Works Approval

Works Approval Number: W5645/2014/1

Decision Document

March 2016 Amendment

Figure 1: Previous Proposal

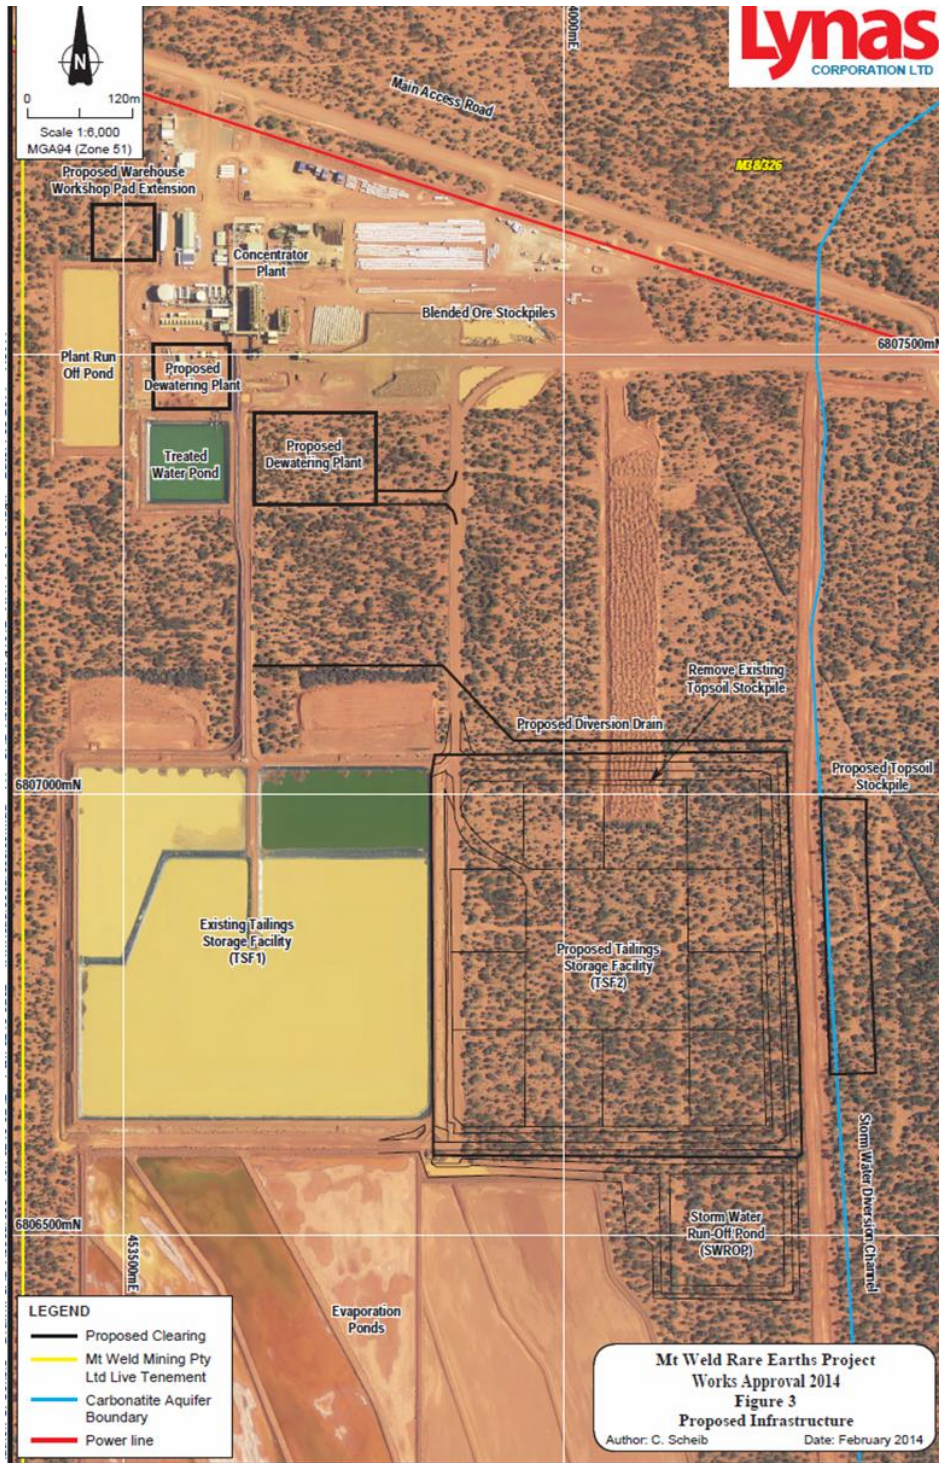
This amendment is to authorise changes to the proponent’s proposal for works for TSF2. The major change is to replace the dry stacking tailings facility with a conventional slurry fed above ground storage facility, similar to TSF1 in design and operation. The geosynthetic clay liner has been retained. As of December 2015, the liner and the Return Water Pond (previously titled SWROP - Storm Water Run-off Pond) have been constructed. The Return Water Pond is designed to function as a conventional tailings decant pond. A summary of the changes is listed below.

Aspect	Originally Proposed Project Element (W5645/2015/1)	Proposed Modification (this document)
Tailings Delivery Infrastructure	Screw press and thickener followed by dry stacking of tailings delivered to TSF2 via haul trucks	Monitored tailings delivery pipelines around crest of TSF2 (similar to TSF1).
Tailings Deposition Method	'Dry' stacking tailings following dewatering to approximately 50% solids.	Deposit tailings as a slurry (approximately 11% solids) via spigot network. A tailings beach is formed with excess water drained to the Raw Water Pond (RWP) (previously referred to as the Storm Water Runoff Pond (SWROP)). The density of beach is approximately 35% solids shortly after deposition, which is air dried.
Decant Return Pump	Decant Return Pump and pipeline back to the Plant with a nominal capacity of 35m ³ /hr	Decant return pump and pipeline back to the plant with a nominal capacity of 200m ³ /hr.

Management of storm water run-off	Diversion drain north of TSF2	Windrows, 0.5 m high, adjacent to the northern toe of TSF2 and along the eastern edge of the TSF1 access road – refer Figure 6.
Storm Water Run Off Pond	Storm Water Run-off Pond	Return Water Pond – this is a change in terminology only, no change in design is proposed.

A revised map showing the location of this infrastructure follows as Figure 2.
